Memorandum

To: Genelle Improvement District **From:** Scott Wallace
Attn: Kim Swetlishoff
Date: December 4, 2018 **File No:** 1589-011

RE: Upper Zone Pressures and PRV Station Assessment

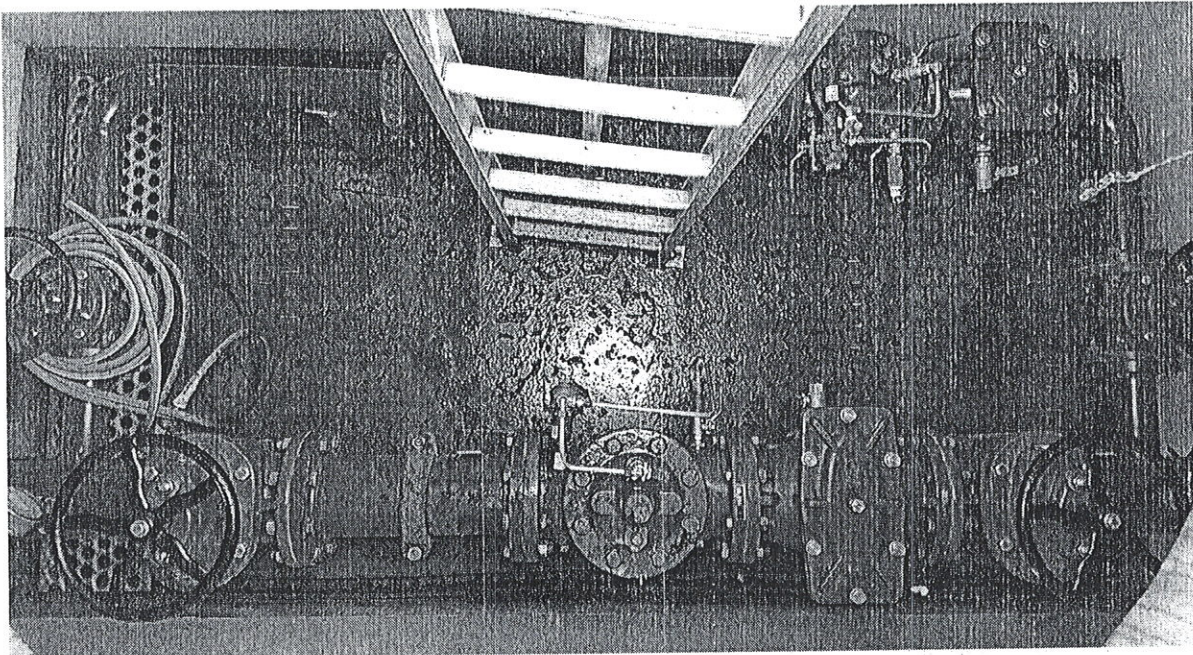
#2 could be dependent on the configuration and operation of the pressure reducing control valves. TRUE reviewed the GID's two PRV stations, and both stations appear to be functioning normally without any unusual flow surging. Further comment specific to the PRVs is in the next section.

In summary, there does not appear to be any system related issues which would cause pressure variability to individual services.

12th Avenue PRV station (located in the road boulevard near civic 329):

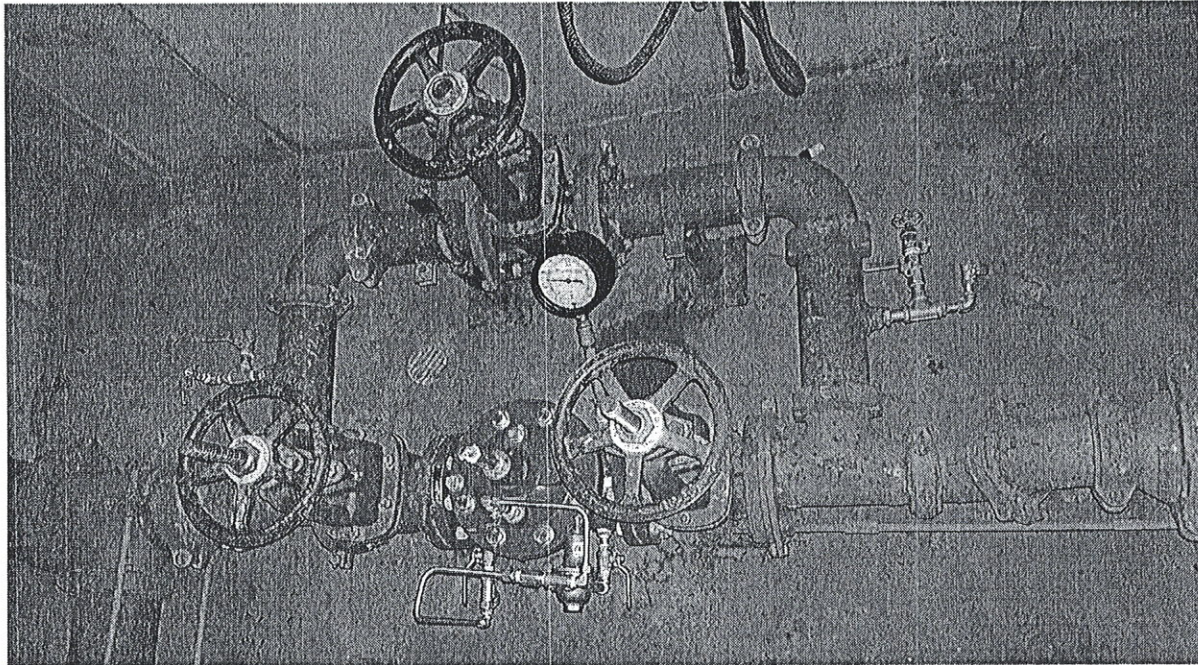
- This is a relatively modern PRV station constructed within the past 15 years, and includes two pressure reducing valves: a 75mm dia. pressure control valve which regulates daily pressures, and a larger 150mm dia. pressure control valve which would open during extreme events such as fireflows. Specific operational data for this PRV station was not reviewed; however, the visual inspection indicated that the 75mm dia. control valve was functioning normally.

- A drain grate is apparent on the chamber floor. It is unclear whether the moisture present on the floor is a result of inadequate ventilation, or non-functional drainage. To preserve and extend the service life of this infrastructure, ventilation and possibly drainage should be improved. Ventilation can be improved through installation of steel gooseneck vent pipes connected at low and high elevations within the chamber. Such vent pipes would be blocked during the coldest months of the year to prevent components freezing in the chamber.

- The PRV station possesses adequate isolation valves for minor service operations, however, as a confined space it does not contain adequate valving outside of the station to allow a full station shut-down for major component replacements. Consideration should be given to installation of station shut down gate valves on watermains outside of the PRV station.
